The Executive Board of the Clean Development Mechanism

**Re: Request for review of the request for issuance for the CDM project activity
'No.2 HFC23 Decomposition Project of Zhejiang Juhua Co., Ltd, P. R. China'
(Ref. No. 0868)**

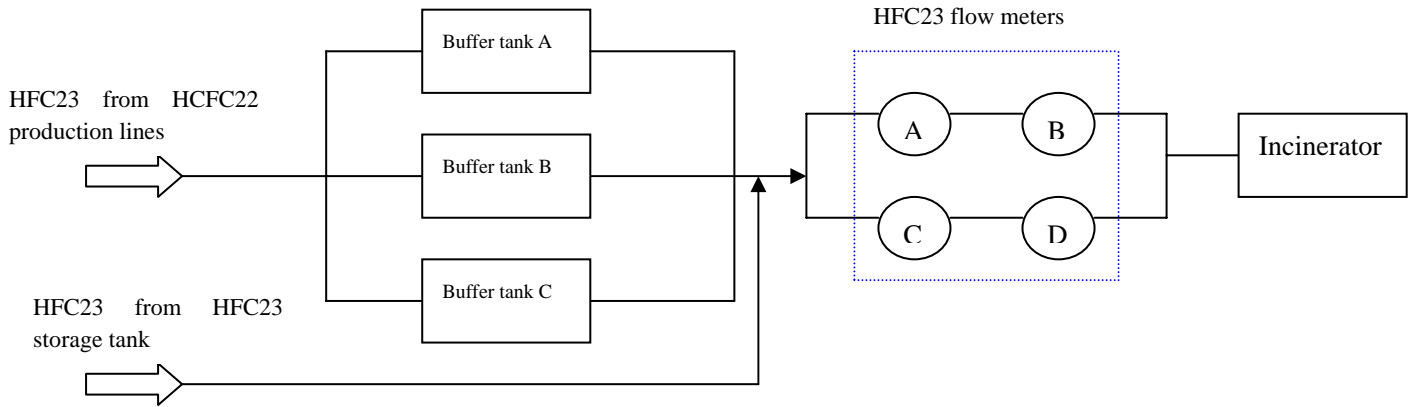
The monitoring report (page 4) stated that "HFC23 waste gas generated in ...is sent to these three HFC23 buffer tanks, after measured by HFC23 flow meters, and then those HFC23 enter into the incinerator to be decomposed." Further clarification is required on how the quantity of HFC23 supplied to the destruction process was measured.

In monitoring report (page 4) stated that *"In this project, there are three HFC23 buffer tanks. HFC23 waste gas generated in No.703 and No.4-703 HCFC22 production lines is sent to these three HFC23 buffer tanks, after measured by HFC23 flow meters, and then those HFC23 enter into the incinerator to be decomposed."* The above description is not very clear, the correct one should be *"In this project, there are three HFC23 buffer tanks. The HFC23 waste gas generated in No.703 and No.4-703 HCFC22 production lines is sent to these three HFC23 buffer tanks first, then HFC23 waste gas will be measured by HFC23 flow meters and finally send to the destruction process."*

In this project, there are three buffer tanks (gas phase tank) .The purpose of buffer tanks is to buffer against the HFC23 generated from No.703 and No.4-703 HCFC22 product lines. When the incinerator shutting down, the HFC23 generated from these HCFC22 product lines would be stored temporarily in these buffer tanks, and be destructed after incinerator is put into operation again. In normal circumstance, those buffer tanks are not used to store HFC23 generated from No.703 and No.4-703 HCFC22 production lines, their function is only to buffer against the HFC23. These three buffer tanks (gas phase tank) were installed before HFC23 flow meters (i.e. flow meters measuring the quantity of HFC23 supplied to the destruction process).

The location relationship between those buffer tanks and the flow meters used to measure the quantity of HFC23 supplied to the destruction process is shown below:
